Certified Action of the City of Raleigh Planning Commission

Case File / Name: **SP-17-10 / University Towers - Amendment**

SUBJECT: SP-17-10 / University Towers - Amendment

Staff Report

SP-17-10 University Towers – site plan

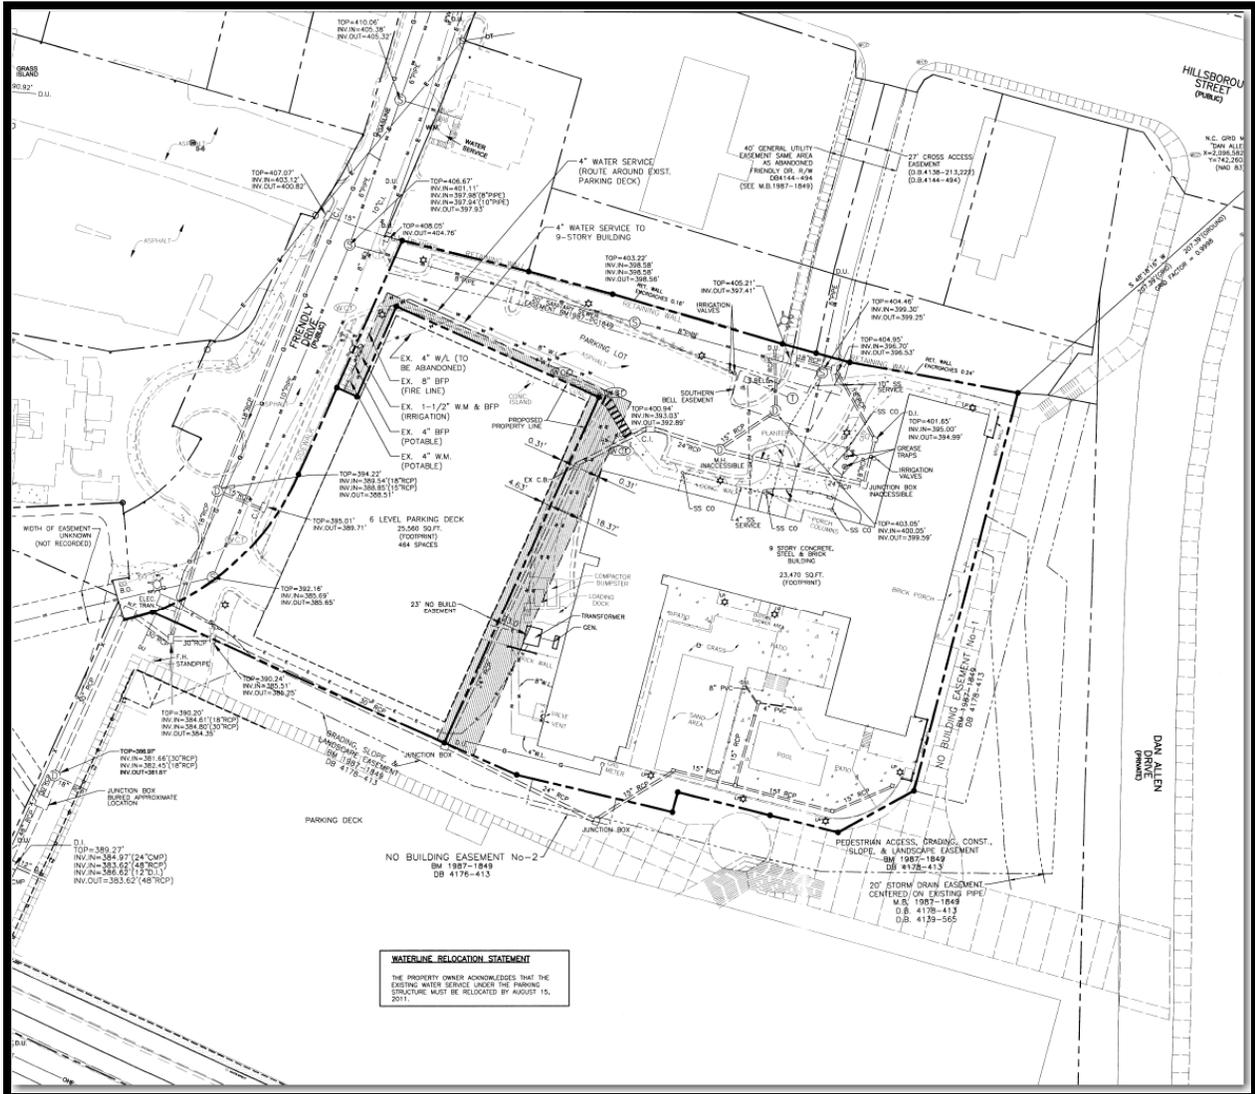
The minimum setback for parcel #2 (parking deck) will be 1.82 feet front yard setback from the new property line and 14.53 feet from Friendly Drive, 4.63 feet rear yard setback from the new property line and 4.90 feet from the side property line adjacent to the hotel site (northern property line) and 10.84 feet from the southern property line of parcel #1.

The minimum setbacks for parcel #1 (hotel) will be 10.86 feet from Dan Allen Drive rear yard setback, front yard setback is 160.28 feet from Friendly Drive and 18.37 feet side yard setback from the new property line of parcel #2.

Key Issues: Does this site plan and its setbacks conform to Code standards 10-2132.2(d) and to adopted land use policies?

- (1) That the Planning Commission first finds that this site plan, conforms to the eight standards for site plan approval, code section 10-2132.2(d);

- (2) That the subdivision plat be recorded, and a recorded copy be given to the Planning Department.
 - (3) That the owner prior to August 15, 2011 will relocate the existing water line as shown on the preliminary site plan;
 - (4) That the no build easements as approved by the City Attorneys office be recorded and a copy provided to the Planning Department.
-
